Field Report No.:				18	
SP&A Project No: 22.331			Report Date: 1.10.2025		
			Time: 9:30AM		
Project: Gales Ferry School (Name & Location) 1854 CT-12 Gales Ferry, CT 06335					
General Contractor: The Imperial Company, Inc.					
Weather		Site Conditions		Day of Week	
☐ Temp. Range: 38° ☒ Clear ☐ Rain ☐ Foggy ☐ Warm ☐ Overcast ☐ Snow ☐ Cold ☐ Hot		☒ Clear ☐ Dusty ☐ Muddy ☐ Windy ☐ Other		☐ Monday ☐ Thursday ☐ Tuesday ☒ Friday ☐ Wednesday ☐ Saturday	
Type of Work Observed Being Performed					
1	☐ Site work	7	☐ General Trades/Drywall	13	☐ Specialties/ Food Service
2	☐ Demolition	8	☐ Windows & Doors	14	☐ Elevators
3	☐ Concrete	9	☐ Roofing	15	☐ Plumbing
4	☐ Masonry	10	☐ Flooring	16	☐ HVAC
5	☐ Steel/Misc. Metals	11	☐ Pool	17	☐ Electrical
6	☐ Carpentry/Casework/ Mill Work	12	☐ Painting/Interior Finishes	18	☐ Temperature Controls/BMS
19	☐ Sprinkler	20	☒ Finish metal	21	☐ Iron workers
		22	☐ Tester (Tri-state)	23	☐ Audio Vis/Low Volt

Roof plan

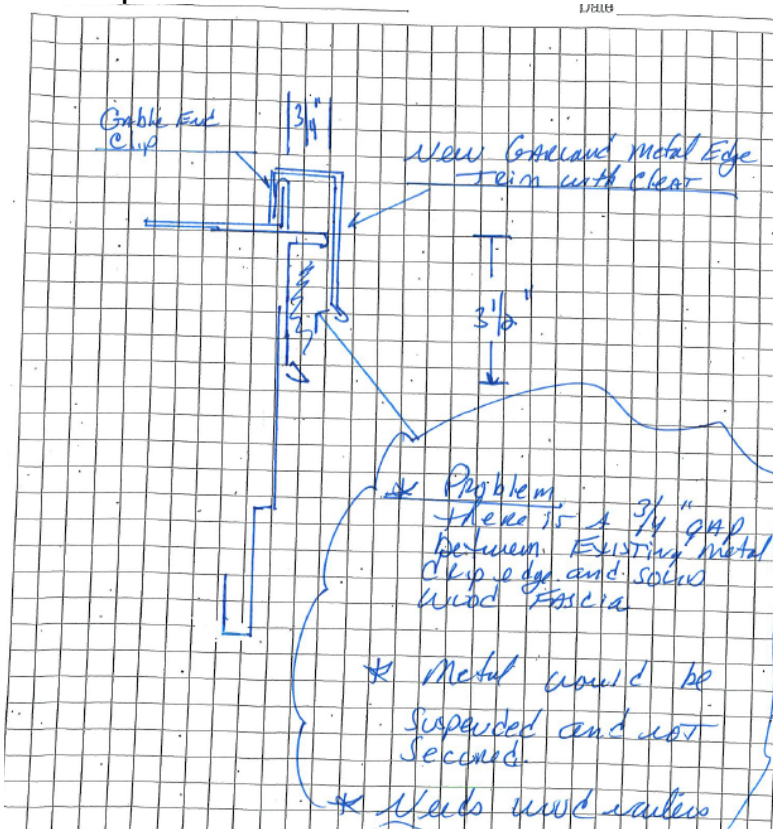
Roof A – In Garland's hands to come up with a solution for the rake connections to the roof on both sides

Garland needs to produce a design for the rakes on the entire job where there is not enough structure to support the new vertical clip
